AREVA Enrichment Services LLC
Eagle Rock Enrichment Facility
NRC Docket No: 70-7015

Subject: Notice of Organization Change for the Eagle Rock Enrichment Facility License Application

Enclosure: 1) AES Organization Change, Marked-up Pages for the Safety Analysis Report and the Quality Assurance Program Description

Figure 1-2 **Rev. 2**
Engineering, Procurement and
Construction (EPC) Organizational Chart
EAGLE ROCK ENRICHMENT FACILITY
QUALITY ASSURANCE PROGRAM DESCRIPTION

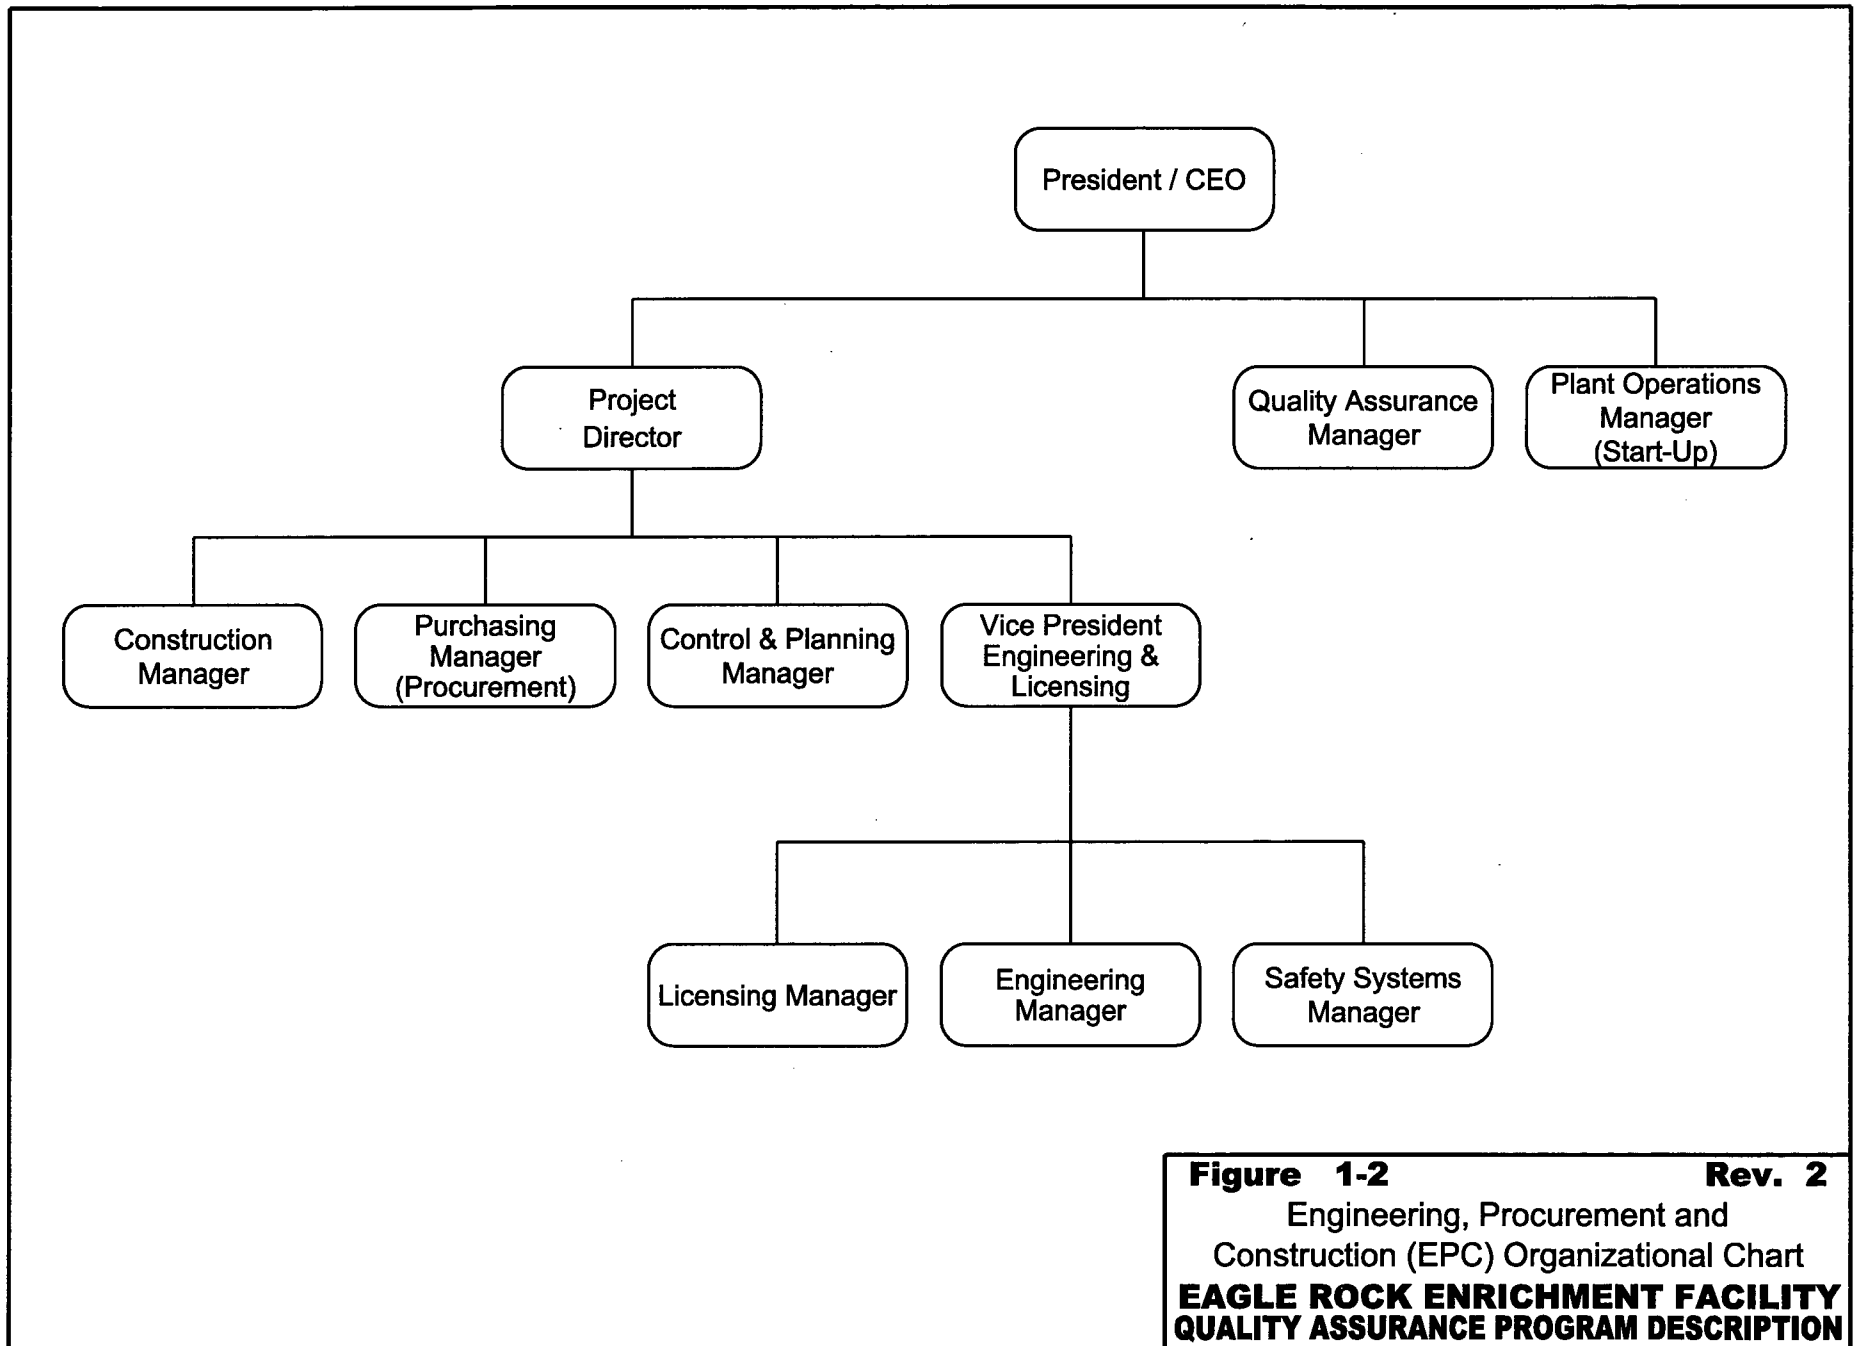
- 1.1.1 AREVA Enrichment Services, LLC (AES) maintains overall responsibility for design, refurbishment, construction, start-up, operations, and decommissioning of the Eagle Rock Enrichment Facility.
- 1.1.2 Figure 1-1 of this QAPD shows the site management operating organization for the Eagle Rock Enrichment Facility (EREF).
- 1.1.3 Figure 1-2 of the QAPD shows the engineering, procurement, construction, and initial start-up organization of the EREF.

- 1.2.3 The AES President has designated the ~~Vice President Engineering and Engineering, Procurement and Construction (EPC) Project Manager~~ the responsibility for design, construction, procurement, and initial start-up for the Eagle Rock Enrichment Facility. The QAPD is binding on all AES and contractor personnel involved with the Eagle Rock Enrichment Facility.

- 1.2.4 ~~A Deputy EPC Project Manager may assist the EPC Project Manager in planning and implementation of EPC activities.~~
- 1.2.5 The AES President has designated the Plant Manager the responsibility for operation, maintenance, and associated support activities for the Eagle Rock Enrichment Facility.

Project Director

The AES President has designated the Plant Operations Manager the responsibility for initial start-up for the EREF.
